RE: WILLMANN RESIDENCE PERMIT Nr.:

PLEASE BE ADVISED OF THE FOLLOWING CHANGES TO THE PORCH FRAMING FOR THE ABOVE REFERENCED PROJECT:

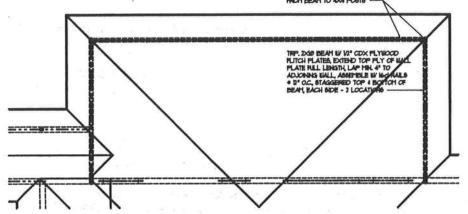
- 1. IN LIEU OF THAT SHOWN IN THE CONSTRUCTION DOCUMENTS, THE PORCH POSTS SHALL BE P/T 4X4 AS SHOWN ON THE ATTACHED DRAWING.
- 2. IN LIEU OF THAT SHOWN IN THE CONSTRUCTION DOCUMENTS, THE PERIMETER SUPPORT BEAMS SHALL BE AD DETAILED IN THE ATTACHED DRAWING. THE BEAM ENDS AT THE HOUSE WALLS SHALL BE DIRECTLY SUPPORTED BY THE WALL FRAMING W/ DBL. "SIMPSON" TS22 STRAPS AR EACH SUPPORT, W/ DBL. JACK STUDS DIRECTLY UNDER THE BEAM ENDS.
